**COUNTY OF VENTURA
PUBLIC WORKS AGENCY
WATERSHED PROTECTION DISTRICT
ZONE 1
URBAN LID RETROFIT
AT MEINERS OAKS**

RECORD DRAWING

URBAN LID RETROFIT AT MEINERS OAKS
GENERAL PLAN

URBAN LID RETROFIT AT MEINERS OAKS
 SITE PLAN

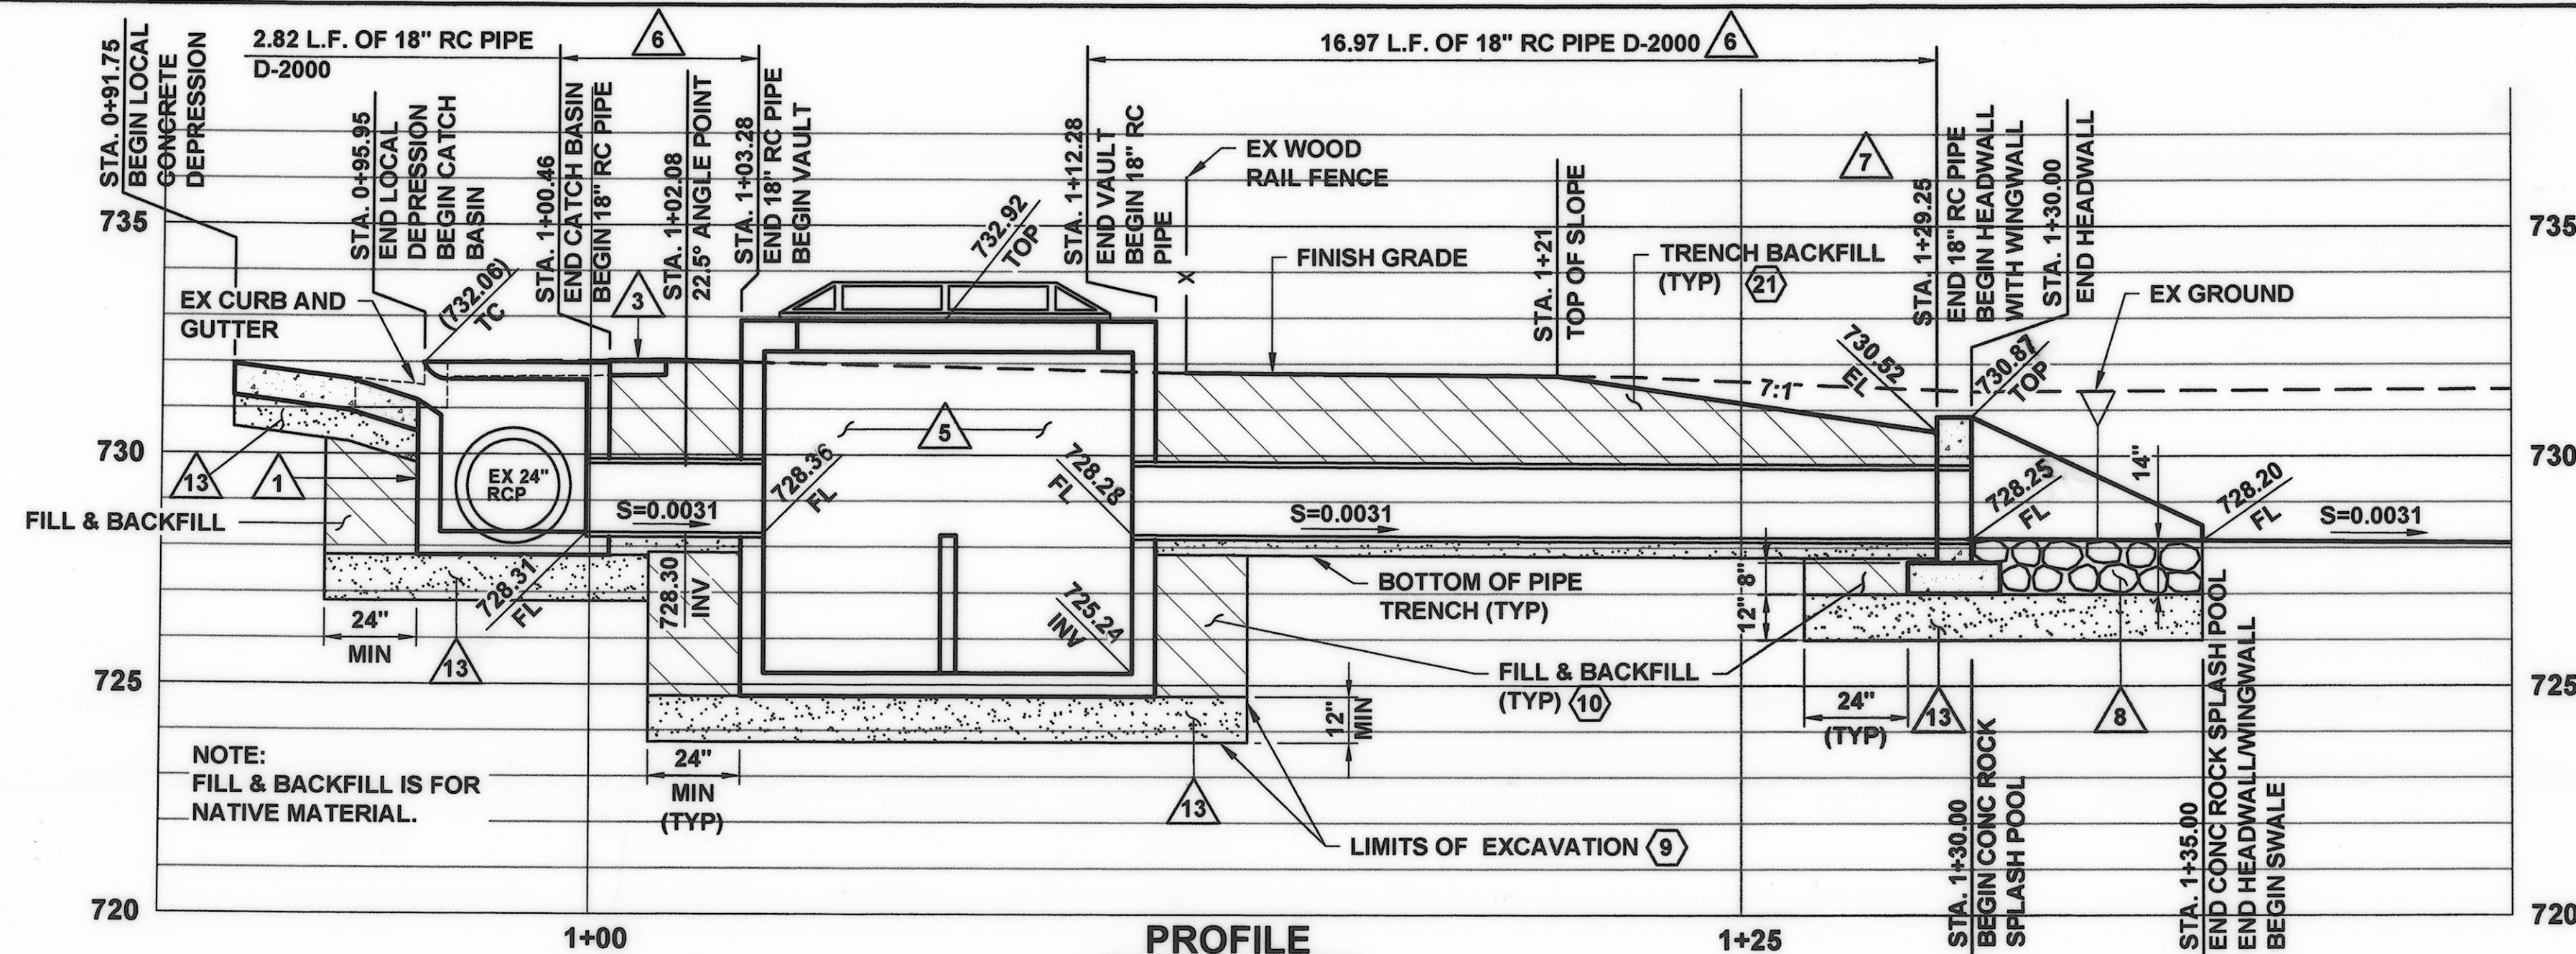
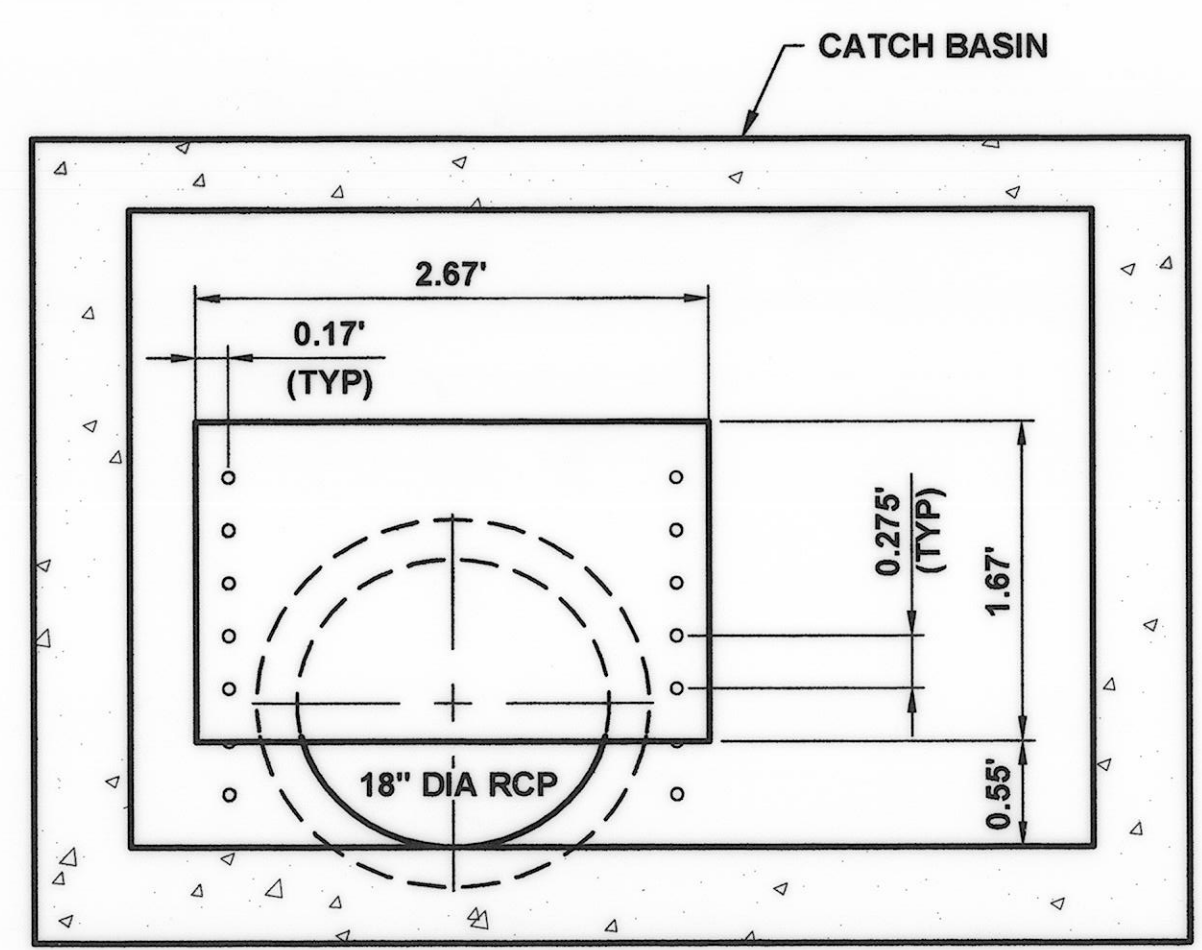
C	WOODEN FENCE ALIGNMENT MODIFIED AS SHOWN.	APP.	DATE
B	MODIFIED CATCH BASIN & TRANSITION STRUCTURE WIDENED 2 FT DUE TO EXISTING ALIGNMENT (CCO#3).		
A	☉ OF PIPE FOUND TO BE 2FT EAST OF ALIGNMENT. AS SHOWN ON THE PLANS.		
REVISION	DESCRIPTION	APP.	DATE

LOW FLOW DIVERSION AND SWALE PRETREATMENT DETAIL
 SCALE: 1" = 3"

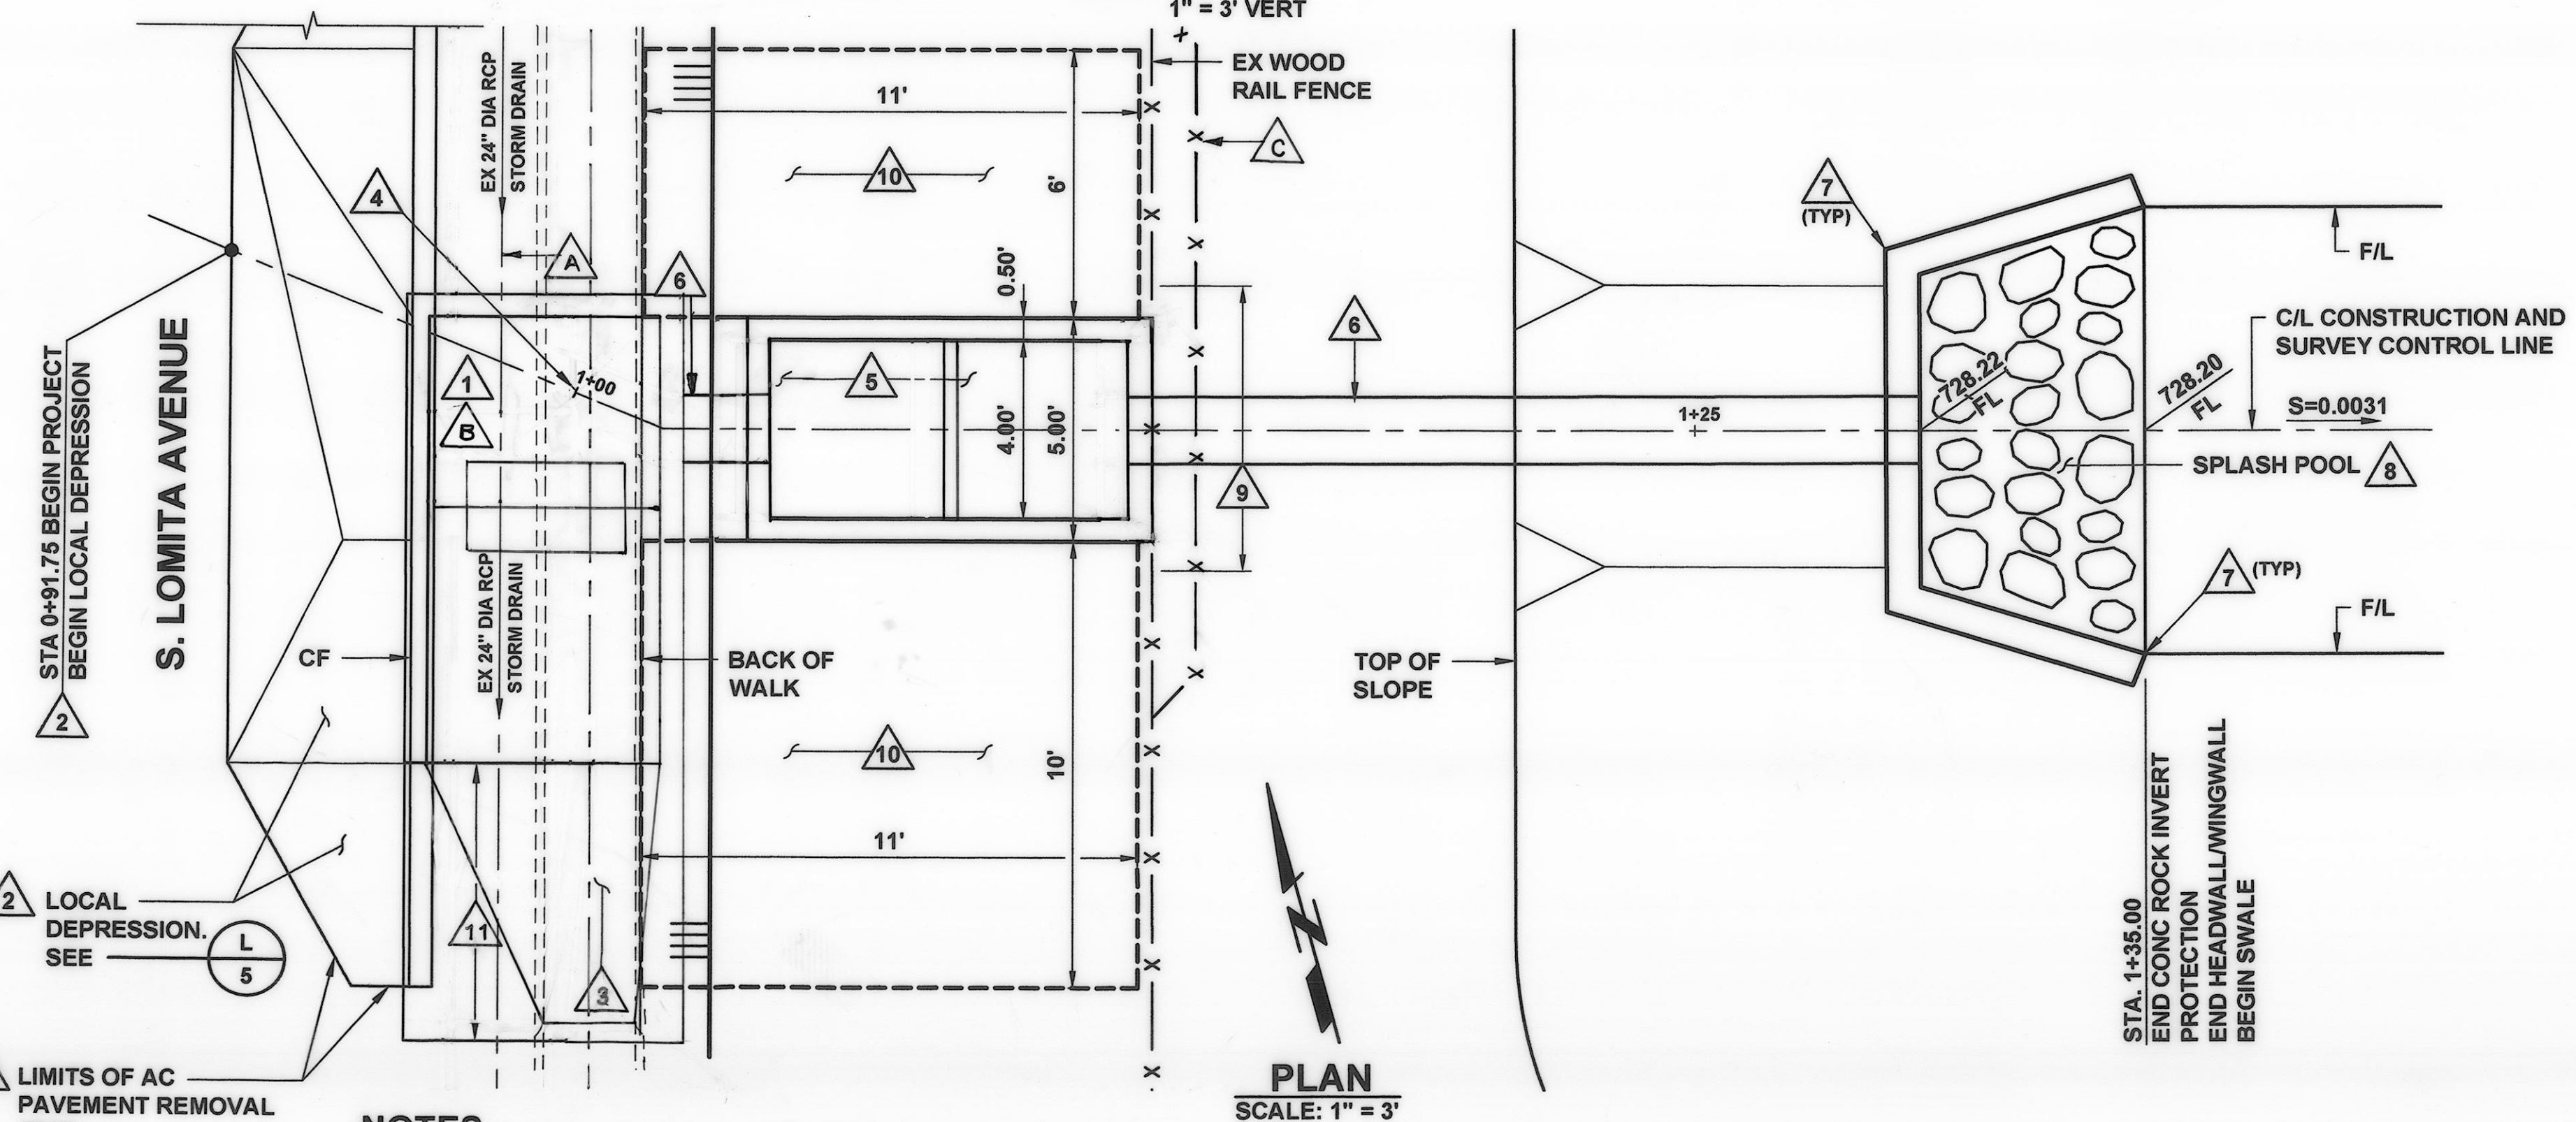
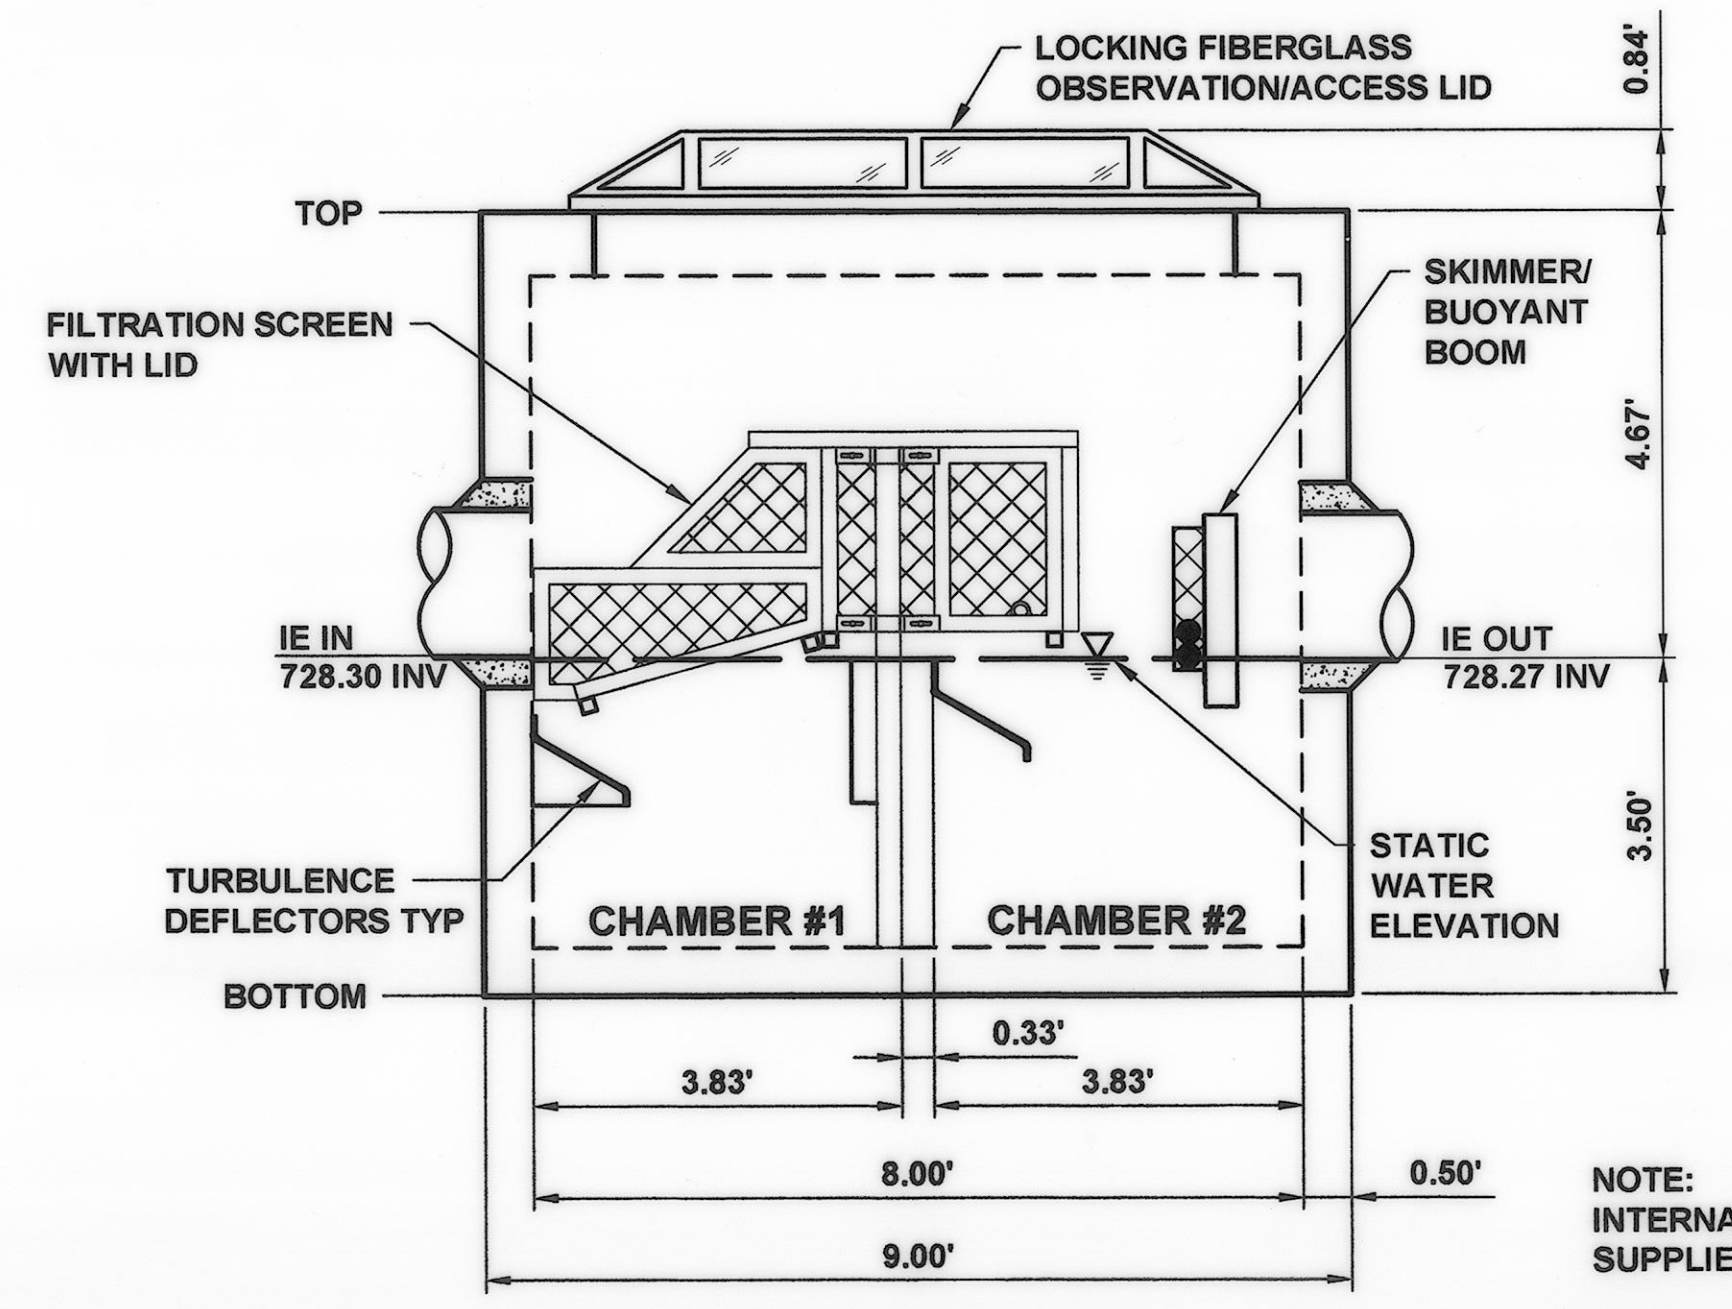
WOODEN FENCE ALIGNMENT MODIFIED AS SHOWN.
 MODIFIED CATCH BASIN & TRANSITION

REVISION	DESCRIPTION	APP.	DATE
1	STRUCTURE WIDENED 2 FT DUE TO EXISTING ALIGNMENT (CCO#3).		
2	OF PIPE FOUND TO BE 2FT EAST. OF ALIGNMENT. AS SHOWN ON THE PLANS.
